**STAFF REPORT: DECEMBER 10, 2025 REGULAR MEETING**

**APPLICATION NUMBER: HDC2025-00725**

**ADDRESS: 4785 STURTEVANT**

**SCOPE: REMOVE HISTORIC WOOD WINDOWS & INSTALL VINYL WINDOWS, REPLACE HISTORIC WOOD DOORS, AND DORMER SIDING**

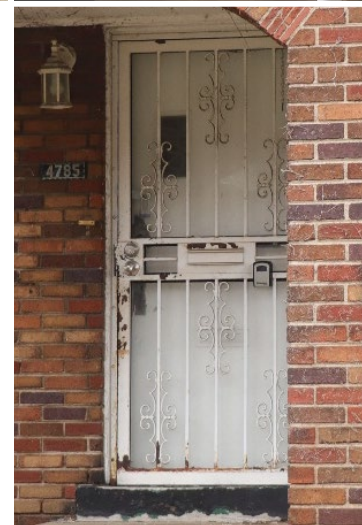
- However, it is staff's opinion that the historic-age wood windows are not beyond feasible repair.
- Additionally, should any windows be proven to be beyond repair, vinyl would not be an appropriate replacement window type for historic buildings, for the following reasons:

- Vinyl windows and poly-products offer a plasticity and flat/thick appearance that does not adequately match the profile/dimensionality and appearance of historic windows

- Consumer-grade vinyl windows weather poorly, deteriorate rapidly and exhibit poor detailing and detracting "bright white" color/sheen.
  - The framing material, glazing, and seals break down more quickly in ultraviolet light than higher quality materials, introducing condensation and other degradation to the insulated glass unit in a few years' time.

- Vinyl also lacks rigidity and can expand and contract more than wood and steel during exposure to weather. This can result in discoloration and warping of the frames and failure of window elements.
